ARCHITECTURAL REVIEW BOARD MEETING
CITY HALL, 385 SOUTH GOLIAD STREET, ROCKWALL, TEXAS
JULY 28, 2026 IN THE CITY COUNCIL CONFERENCE ROOM AT 5:00 PM

PROJECT COMMENTS

PROJECT NUMBER: SP2026-014
PROJECT NAME: Site Plan for 5133 S FM 549
SITE ADDRESS/LOCATIONS: 5133 South Farm to Market 549, Rockwall, TX, 75032

PLANNING AND ZONING COMMISSION MEMORANDUM

LEFT (WEST) ELEVATION

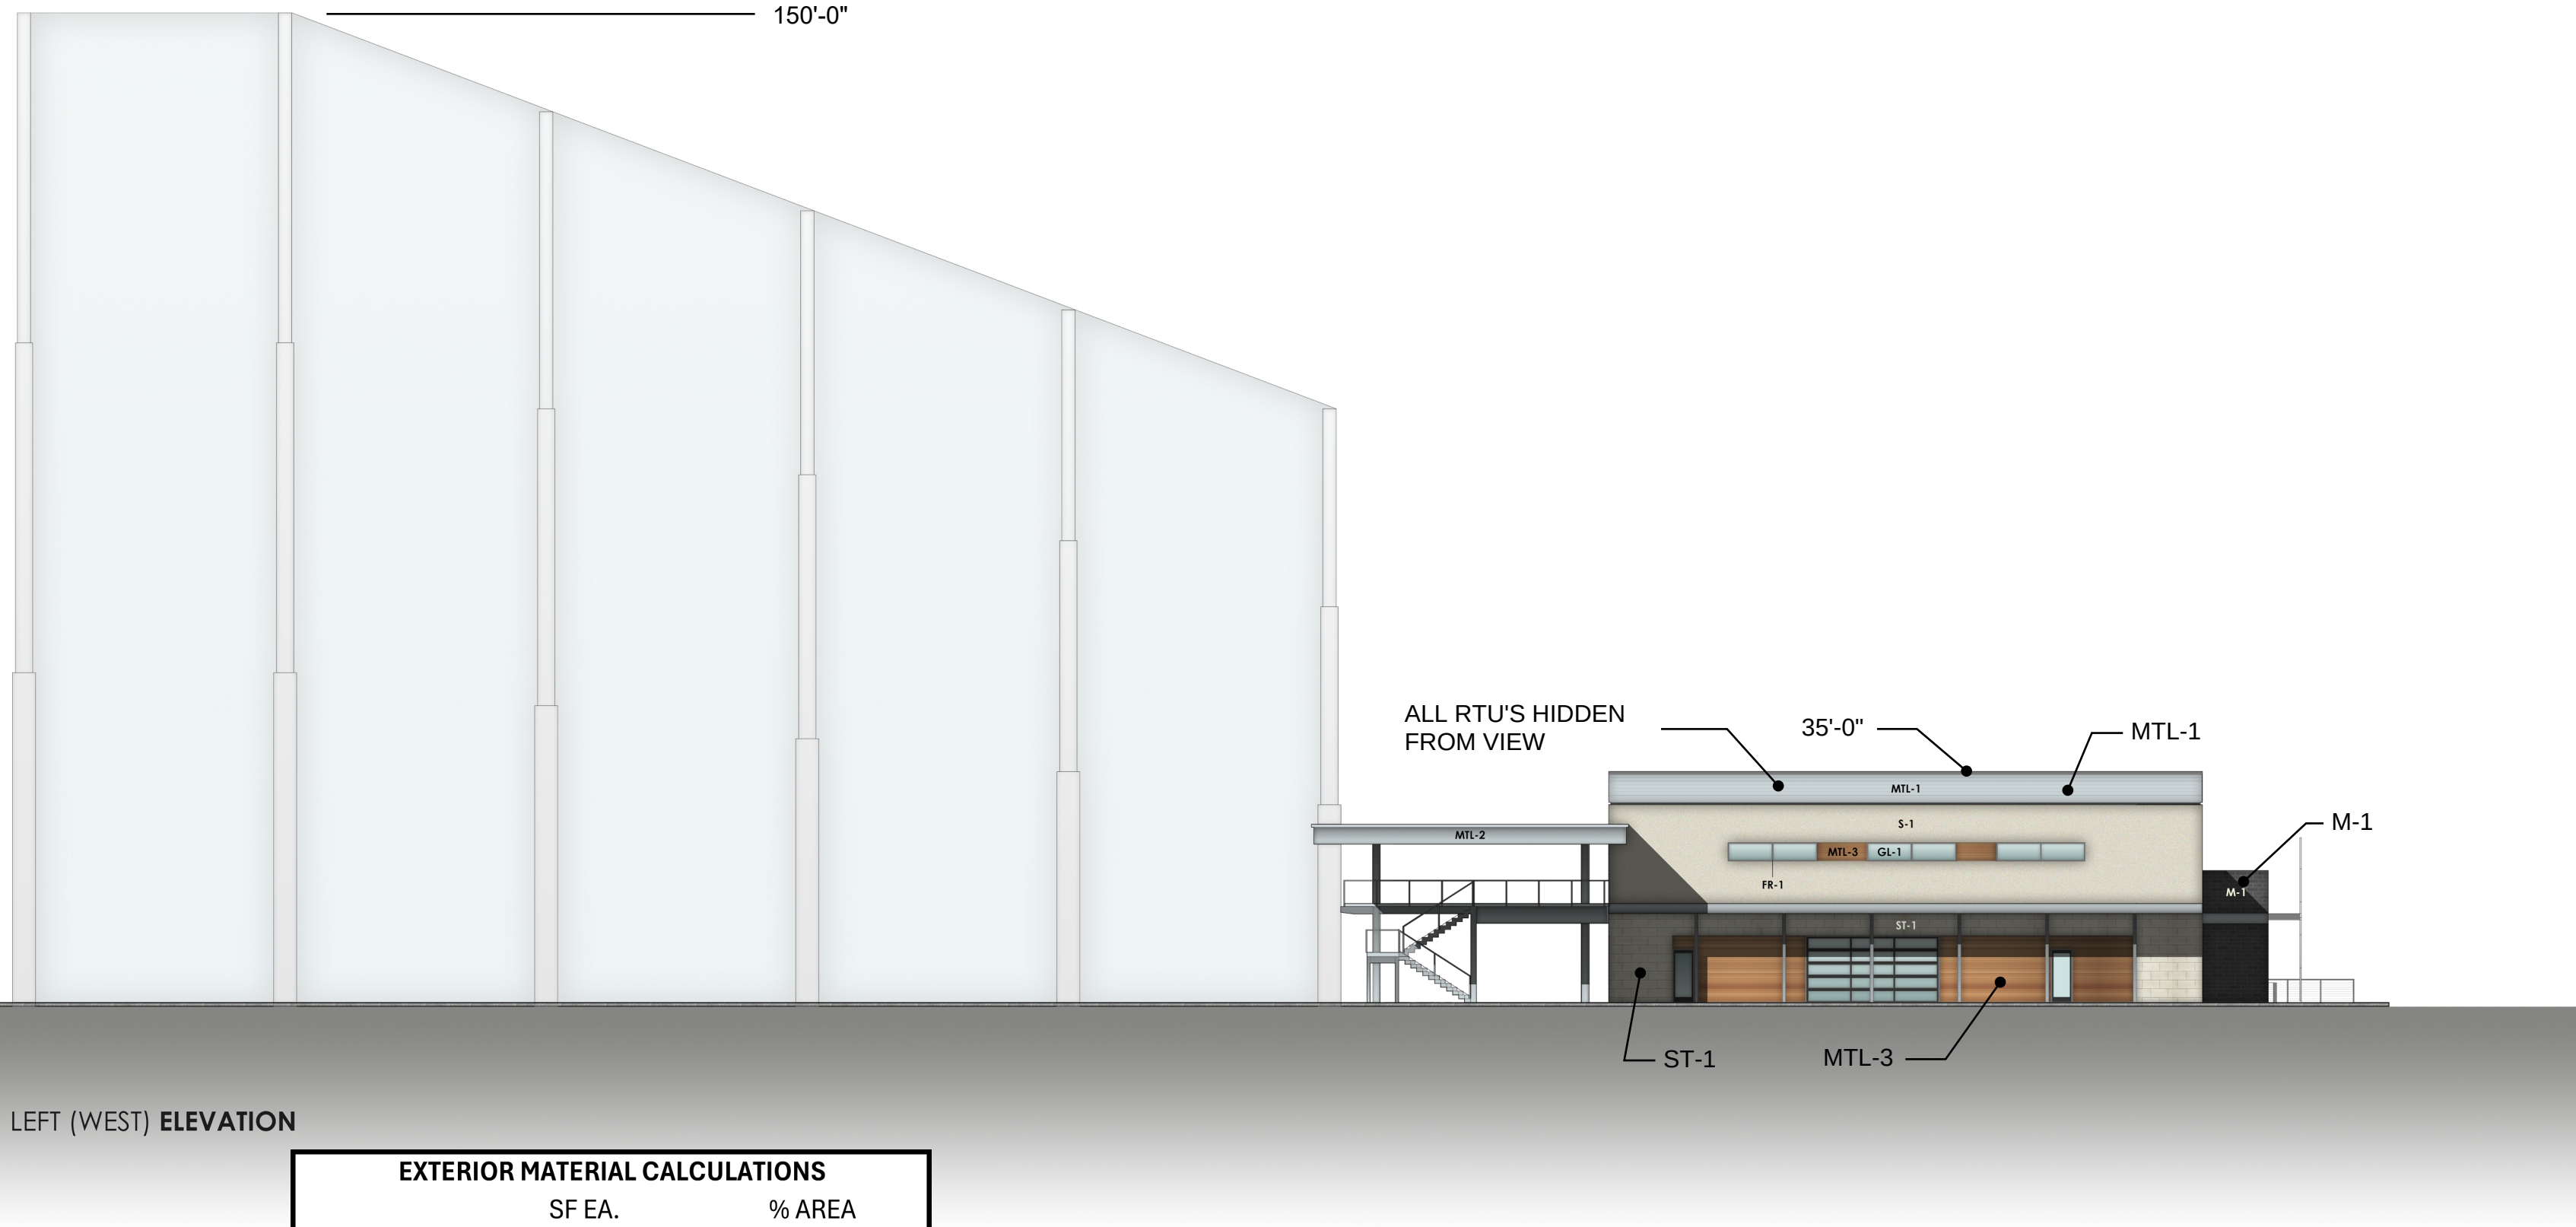
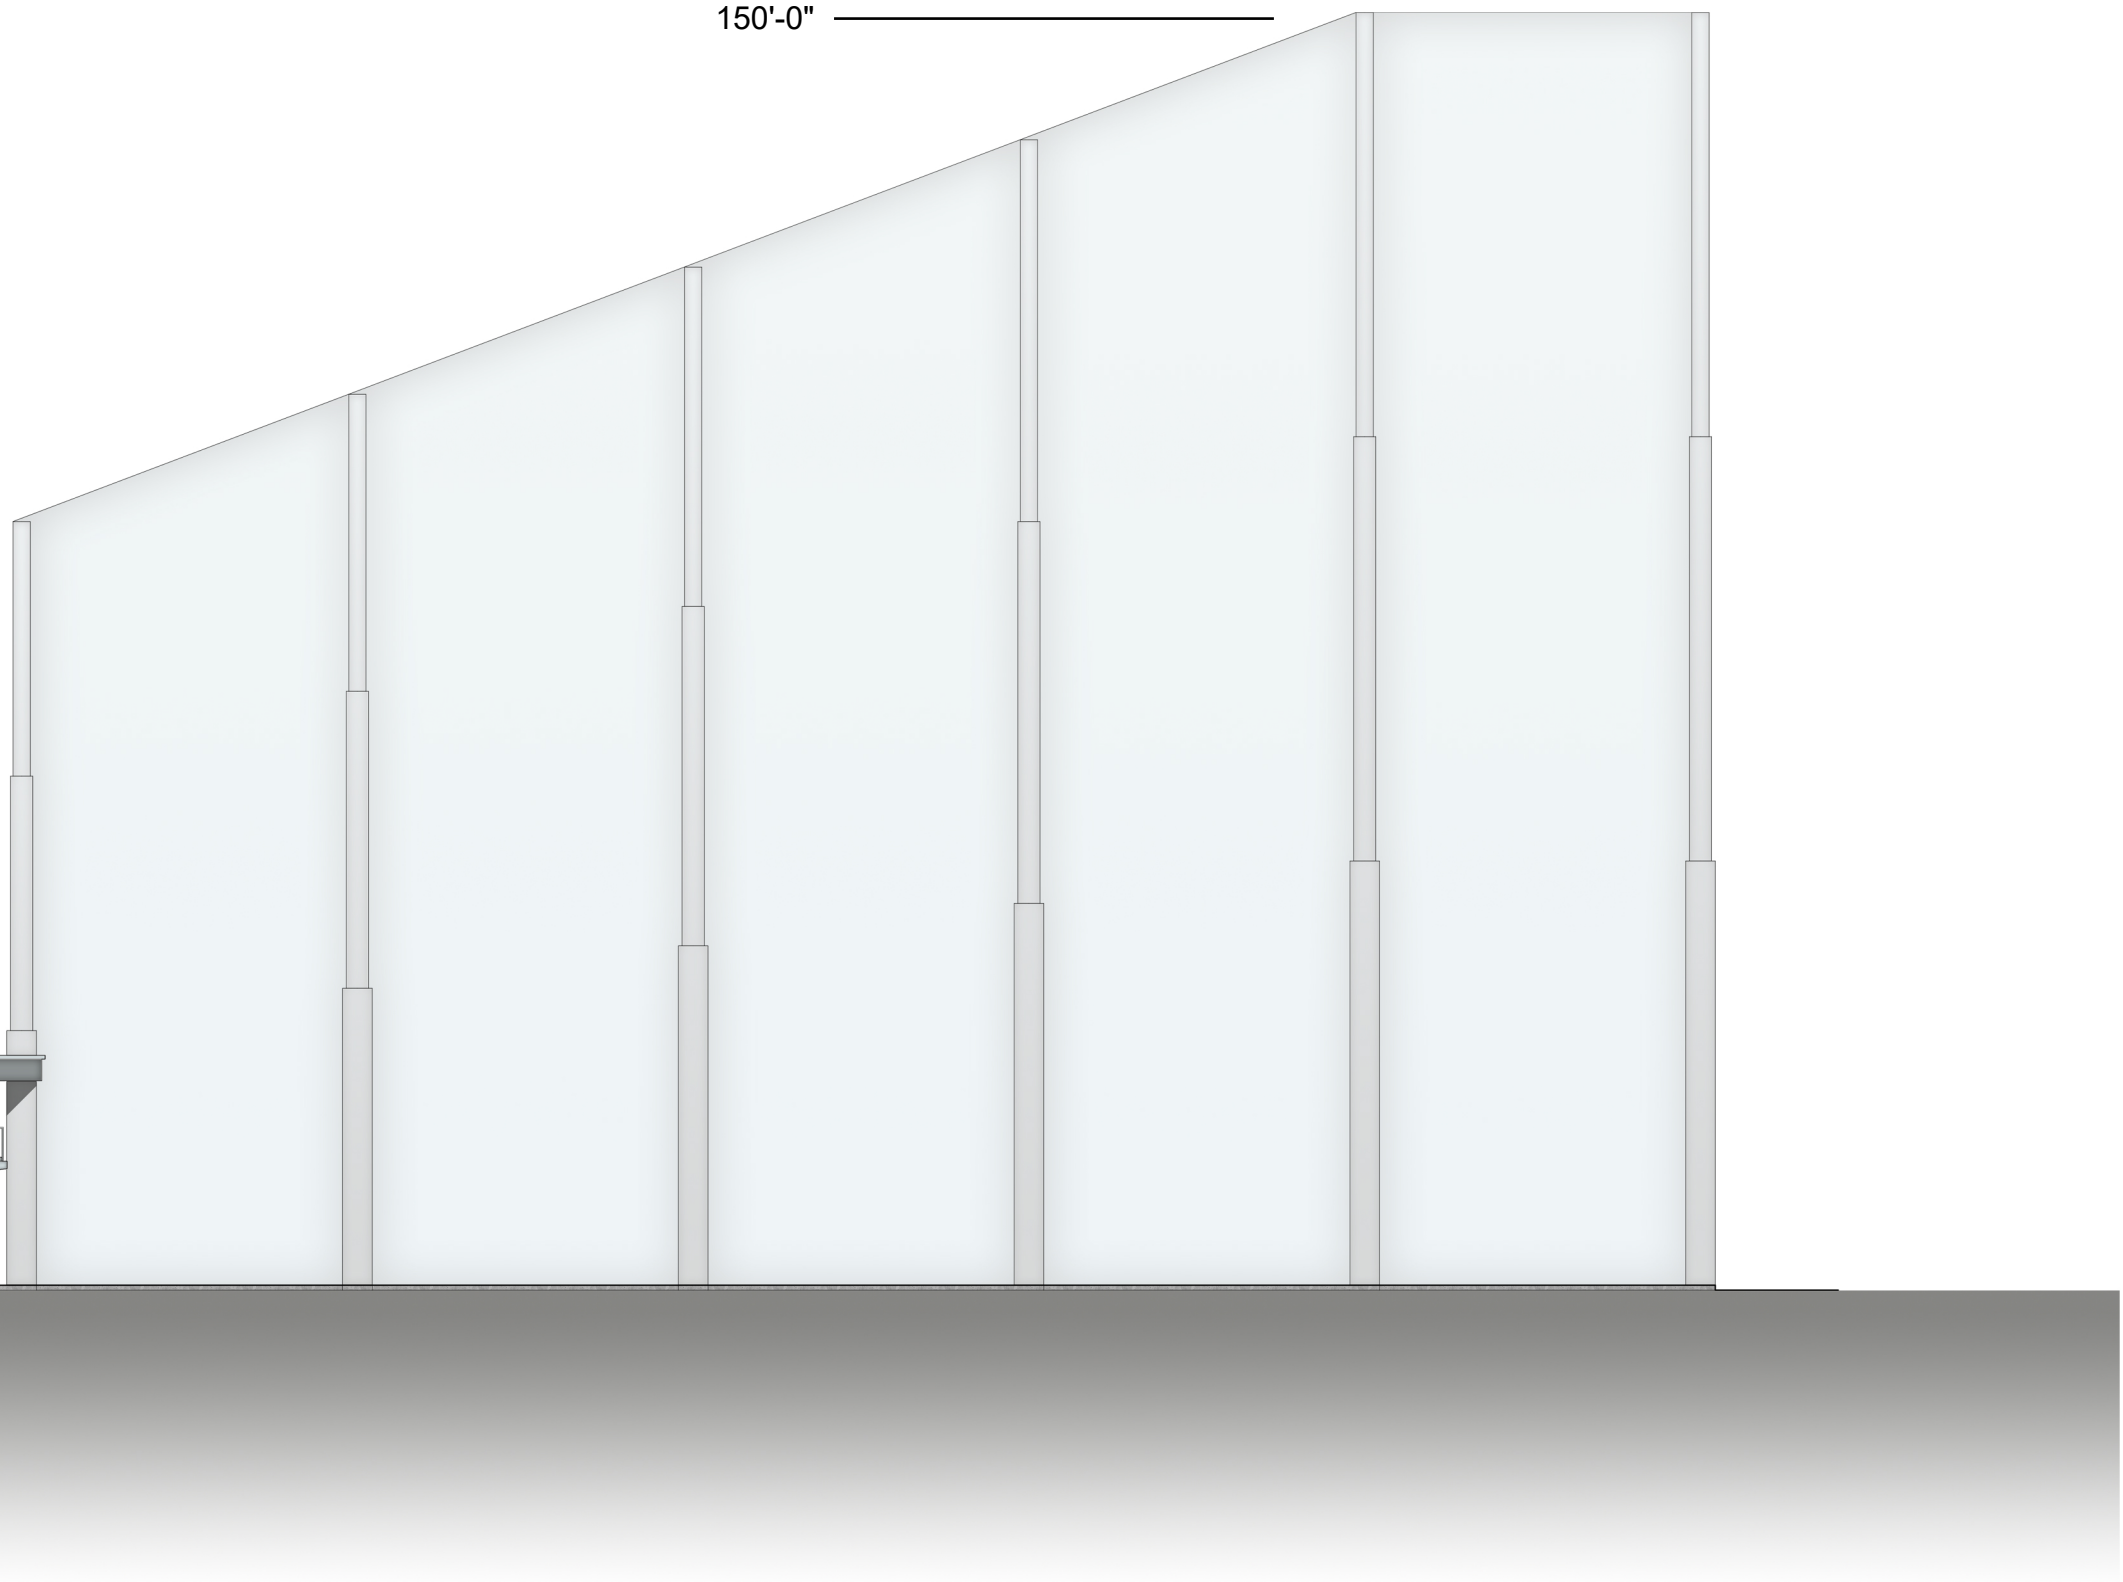
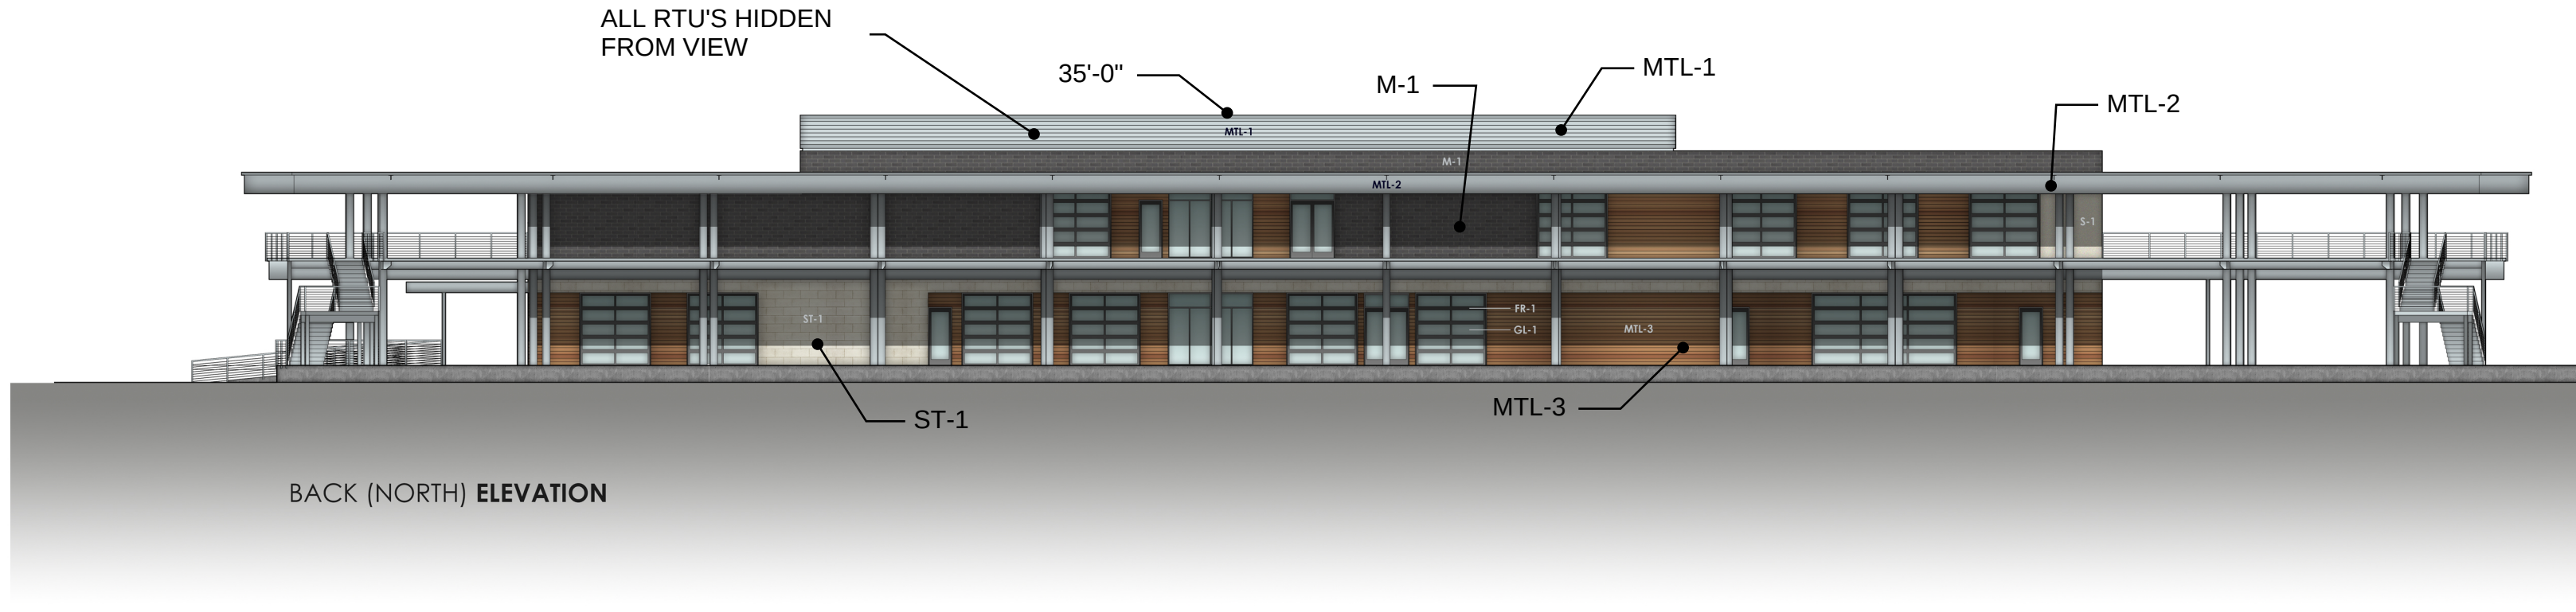
- (1) Please provide the building elevation for the maintenance building. (Subsection 03.04. B, of Article 11, UDC)
- (2) Please provide supplementary elevations of the primary building that does not have the netting included. (Subsection 03.04. B, of Article 11, UDC)
